### APPEAL SUMMARY

**Status:** Decision Rendered - Reconsideration of ID 18523

<b>Appeal ID:</b> 18950	<b>Project Address:</b> 3384B SE Gladstone St
<b>Hearing Date:</b> 2/6/19	<b>Appellant Name:</b> Holly Braun
<b>Case No.:</b> B-005	<b>Appellant Phone:</b> 5038874538
<b>Appeal Type:</b> Building	<b>Plans Examiner/Inspector:</b> Jacob Carrington
<b>Project Type:</b> residential	<b>Stories:</b> 3 <b>Occupancy:</b> R5 <b>Construction Type:</b> Wood
<b>Building/Business Name:</b>	<b>Fire Sprinklers:</b> No
<b>Appeal Involves:</b> Alteration of an existing structure, Reconsideration of appeal	<b>LUR or Permit Application No.:</b> 17-260574-RS
<b>Plan Submitted Option:</b> pdf [File 1] [File 2]	<b>Proposed use:</b> ADU

## EAST ELEVATION

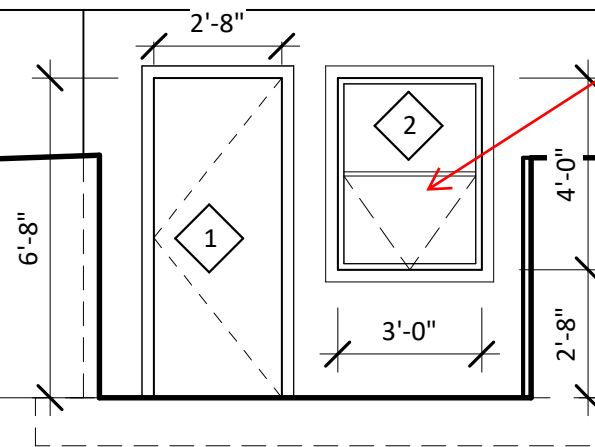
<b>Code Section</b>	City of Portland Handout #10 - Windows
<b>Requires</b>	City of Portland Windows guide states that "Safety glass that has been tested and labeled, also known as tempered glass is required in window in the following location: Windows that are both within 24" of a door in a closed position and within 60" of the floor"

**Proposed Design** In lieu of replacing existing panes with tempered glass, we propose using an applied film product (CL-70-XSR Madico Protekt Film). See attached specification.

**Reason for alternative** No suitable tempered glass application could be found from the original manufacturer. The film application meets all ANSI requirements for tempered glass.

**2. Use of plastic film in lieu of safety glazing: Granted provided film is applied per manufacturer's specifications.**
